ZBA SET REV'D 12-2-20

NEW ROOF DECK W/ NEW HATCH ACCESS SUBJECT TO S.E.L.C. APPROVAL) REMOVE EXST'G REMOVE EXST'G WYLIGHT CARACTER STG DORMER: REPLACE (3) WINDOWS	PROPOSED	ELEVATIONS
EXST'G FIRE ESCAPE AND STAIRWAY TO REMAIN.	PROPOSED RENOVATIONS	BOSTON, MA.
	TIMOTHY SHEEHAN ARCHITECT 9 WALL STREET	CHARLESTOWN, MA. 02129
	REV:	START DATE: 6/6/20 DRAWN BY: TS SCALE: 1/8" = 1'-0" PROJECT #: 2020-20
CK RFV'D 6-29-21		A 3

ROOF DECK REV'D 6-29-21

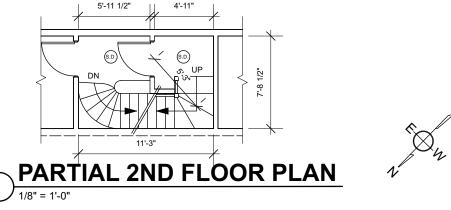
PLEASE REMOVE F.A.R. VIOLATION. G.S.F. WILL REMAIN THE SAME AS EXISTING.

REAR DECK AT FOURTH FLOOR REDUCED FROM 6'-10" TO 5'-0"
